**Board of Zoning Appeals Staff Report
September 25, 2023 Meeting**

**6880 MARGARUM BEND
ENCROACHMENT VARIANCE**

LOCATION: 6880 Margarum Bend (PID: 222-003158)
APPLICANT: The city of New Albany
REQUEST: Variance to allow a building and paver patio to encroach a platted drainage easement.
ZONING: I-PUD (Planned Unit Development District)
STRATEGIC PLAN: Residential
APPLICATION: VAR-82-2023

Subject Property
  Location of stormwater water inlets and pipes

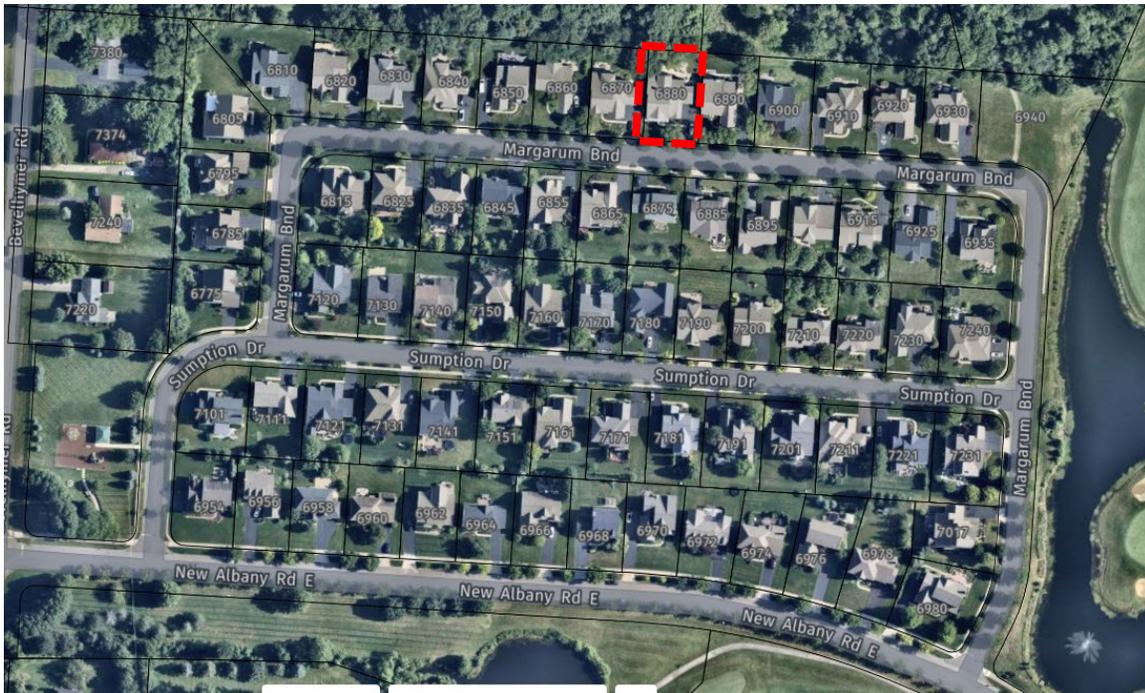
4. According to the approved engineering plans for the subdivision, this easement runs along the rear property line of 12 homes along this section of Margarum Bend and provides stormwater drainage for the properties north.

- The variance request does not appear to be substantial. The applicant's property (lot 436) sits at the highest grade of the easement which prevents stormwater from pooling in the rear yard. Since the property is at the highest grade it does not obstruct the conveyance of water from neighboring properties.

- The easement is not a major flood route. The easement is used to convey stormwater into an inlet as shown in the picture below. According to these plans, the stormwater (surface runoff) drains along a portion of the rear and to the front of the home into the street. There are no impacts of water to their neighbors.

- The variance preserves the "spirit and intent" of the zoning requirement and it appears "substantial justice" would be done by granting the variance. The 28 foot wide drainage easement is oversized based on the approved engineering plans for the subdivision. The engineering plans for the stormwater collection and conveyance shows it is designed to be within a 10 foot easement off of the rear property line.

1. The homeowner enters into a hold harmless agreement (or similar legal mechanism to be determined by the city engineer and/or attorney) specifying that the property owner, and not the city, is responsible for any damages to the building or patio in the event that a public or private utility provider needs to access the easement area prior to the issuance of a building permit and any impacts to neighboring surface drainage must be the responsibility of the homeowner to address.

FOUNDATION PLAN
 SCALE: 1/4" = 1'-0" (22/34)
 1/8" = 1'-0" (18/17)

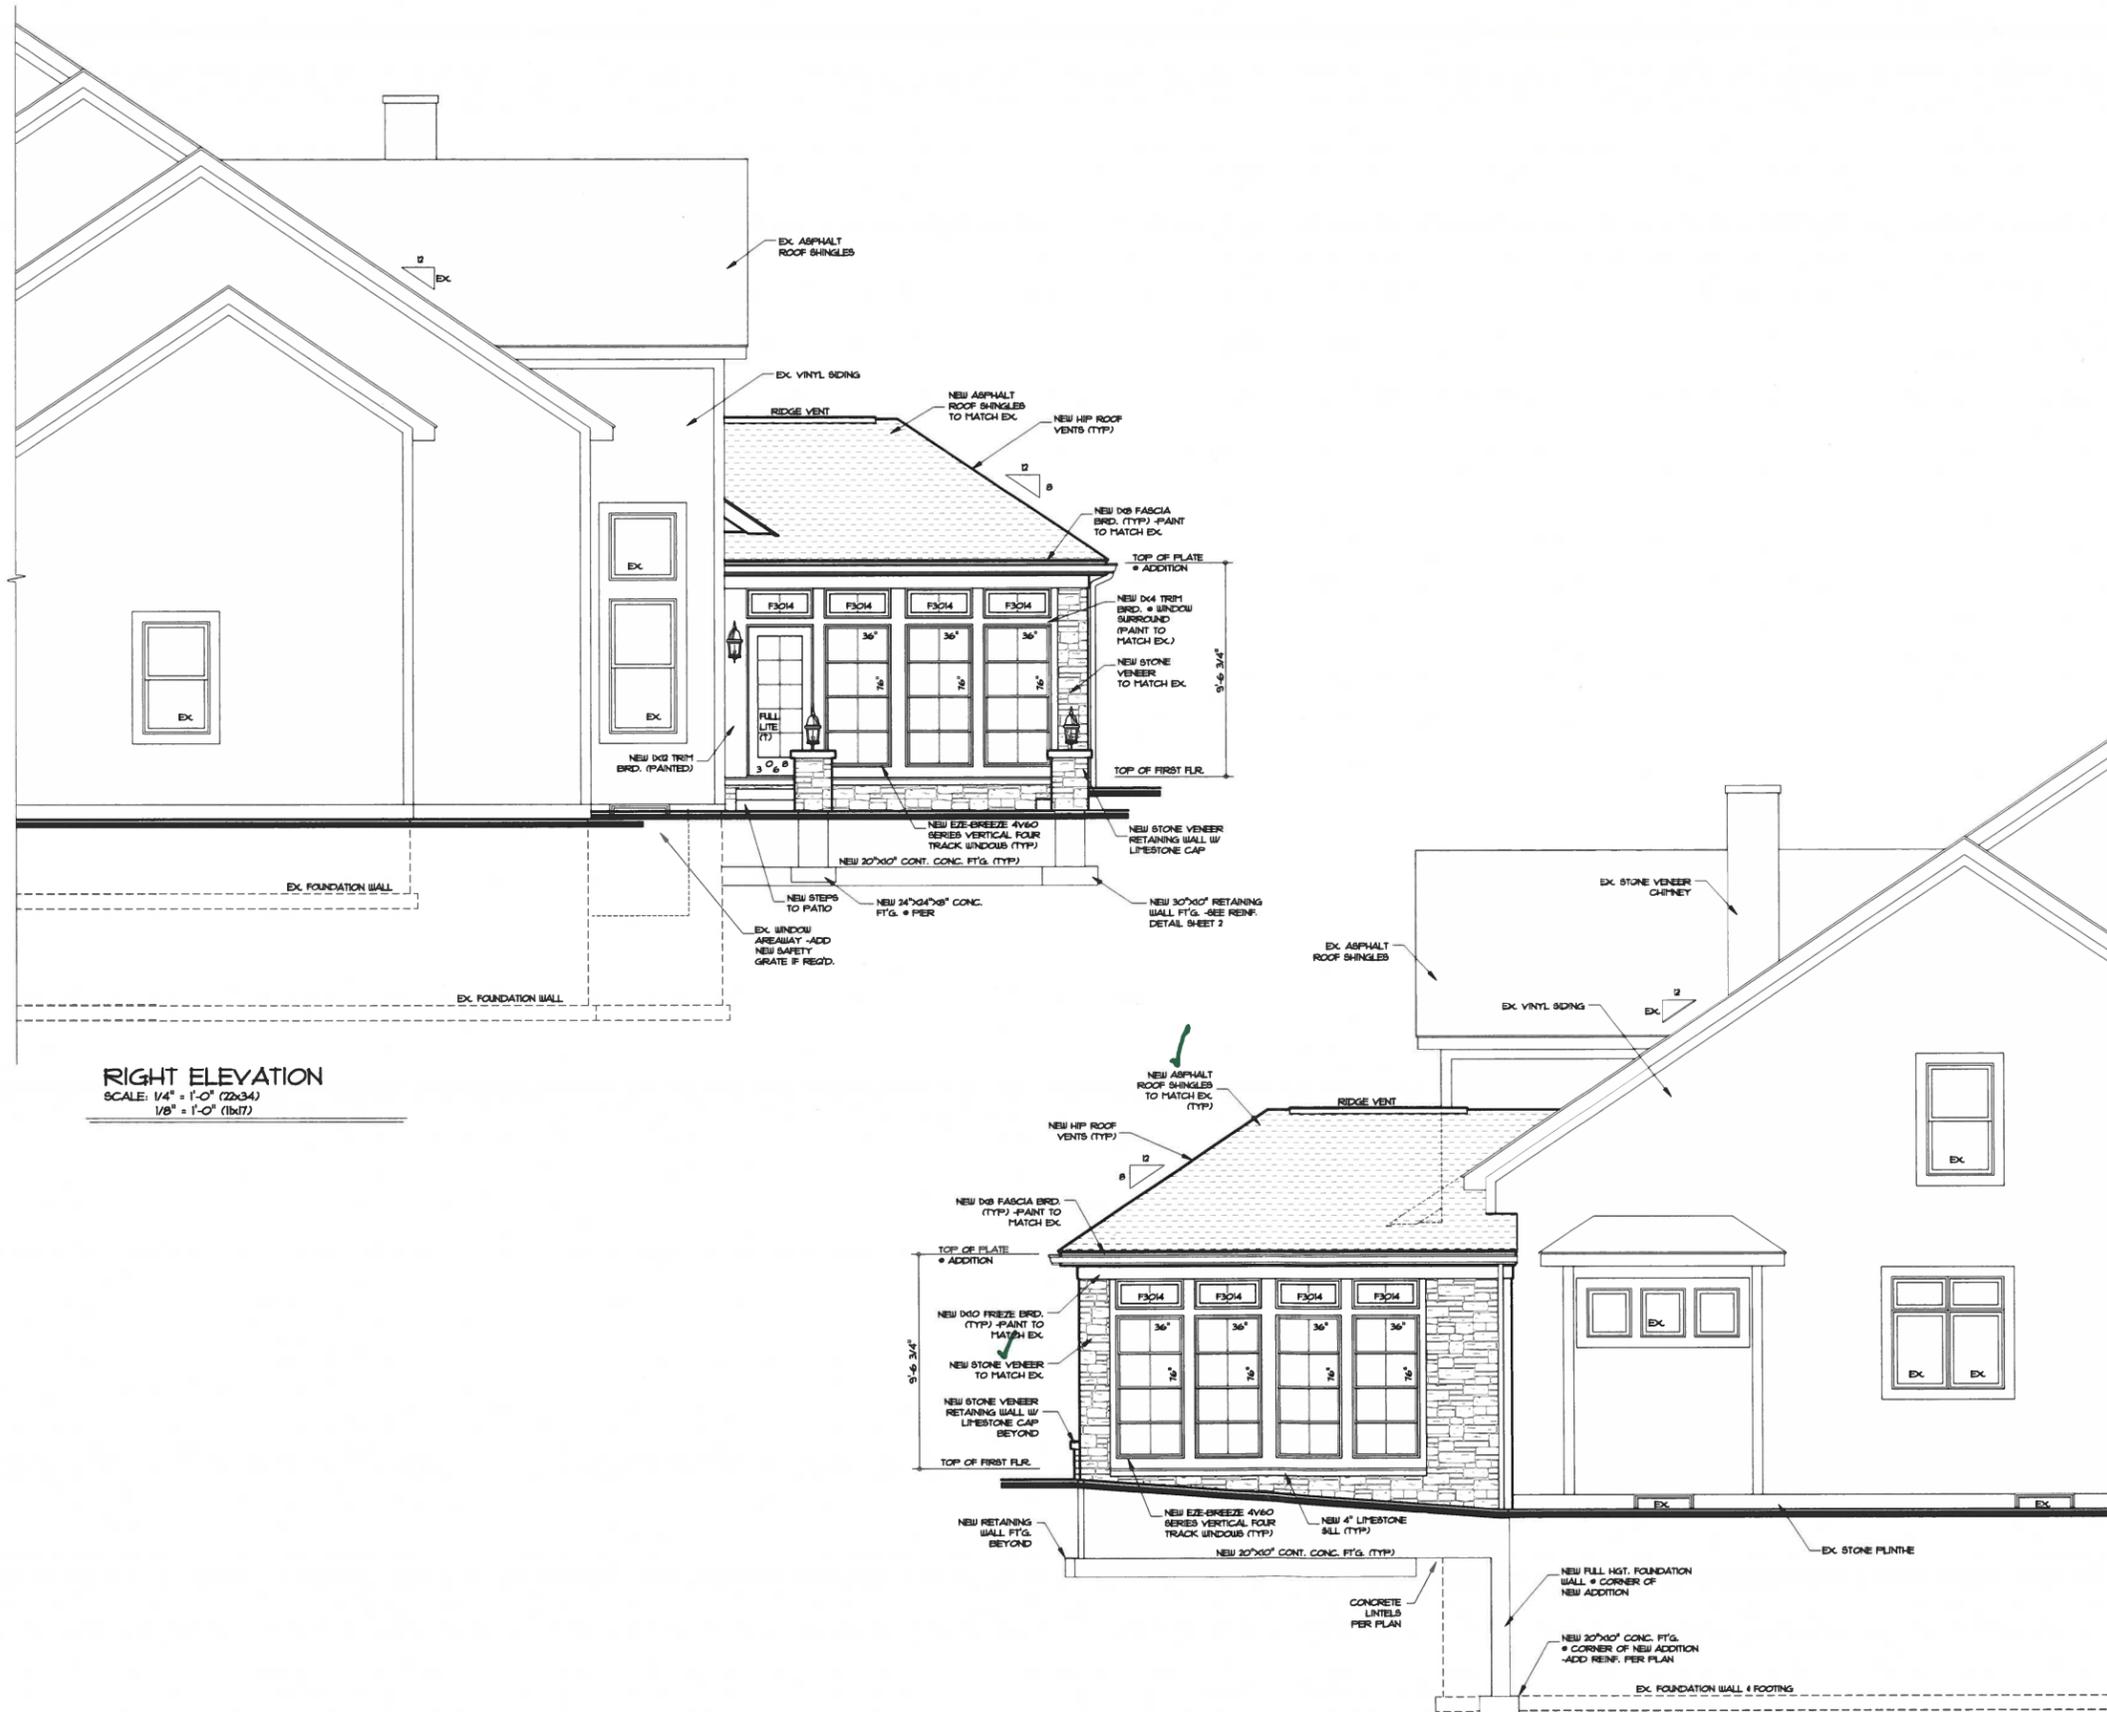
** CHANGE NO LONGER DOING THIS CHANGE TO STALK STONE PAV*
